CERTIFICATE OF APPROPRIATENESS

Property: 400 Cordell Street, Lot 5 and 6, Tract 1, Block 26, Brooke Smith Subdivision. The property includes a historic one-story wood frame 1,209 square foot single-family residence and a detached garage situated on a 5,000 square foot (50' x 100') corner lot.,

Significance: Whitaker-Graliano-Brown House is a City of Houston Protected Landmark designated in September of 2013. The Bungalow-style one-story historic residence was constructed circa 1918.

Proposal: Alteration – *Revision* The applicant was granted a Certificate of Appropriateness in May of 2014 to construct a two story addition to the rear of a one story Protected Landmark. The applicant now proposes the following revisions:

SOUTH SIDE ELEVATION

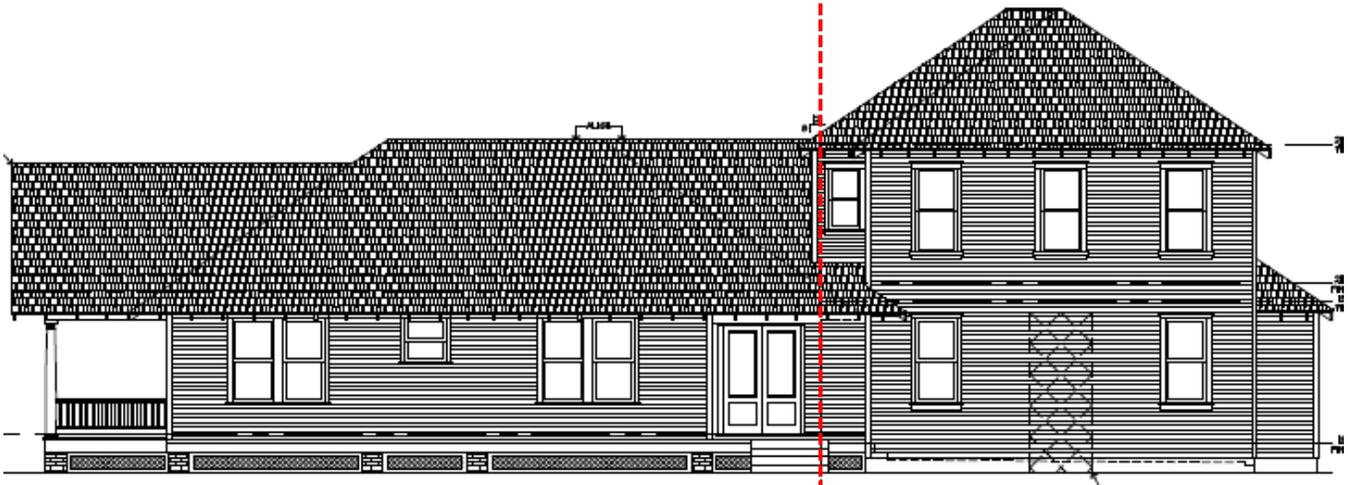
- The applicant originally proposed to restore a rear covered porch on the south side (facing Melwood Street) elevation. This would delineate the addition from the historic structure. The applicant now proposes to keep this area enclosed but inset the wall by 1' to delineate the addition from the existing structure.

Proposed Revision: The applicant now proposes to keep the south facing porch enclosed. The new porch enclosure will be inset 1' from the existing wall to delineate the break between the historic home and the new addition/

**FIRST FLOOR PLAN
EXISTING**

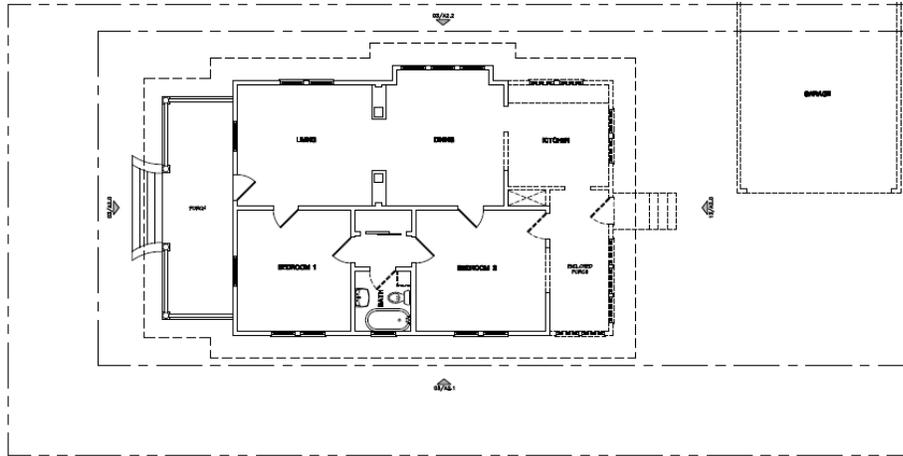
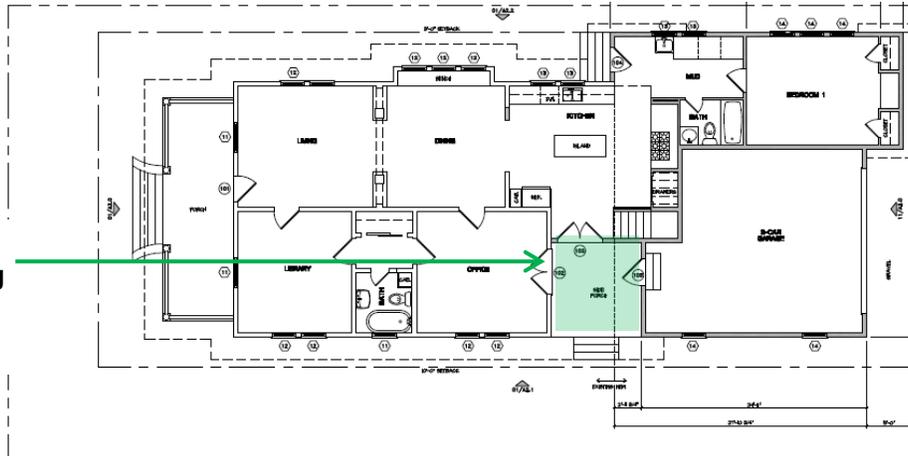
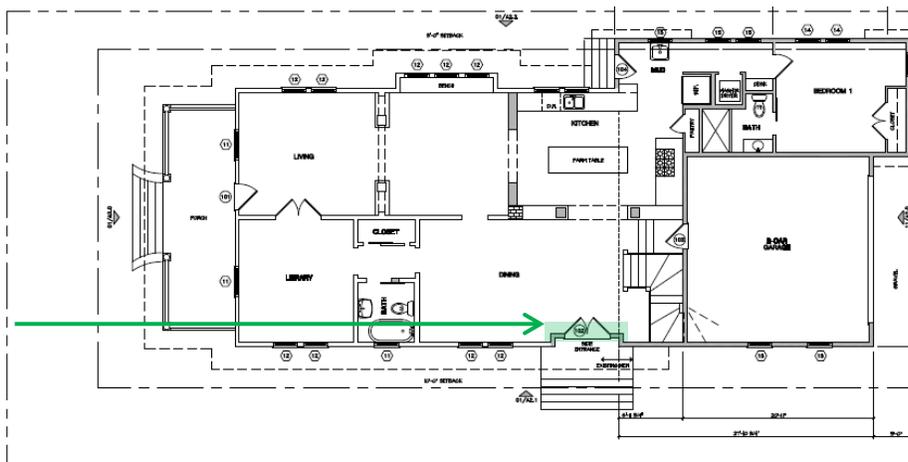
Approved: open porch separating addition from existing home

Proposed: dining room expanded to encompass the previously proposed porch area.
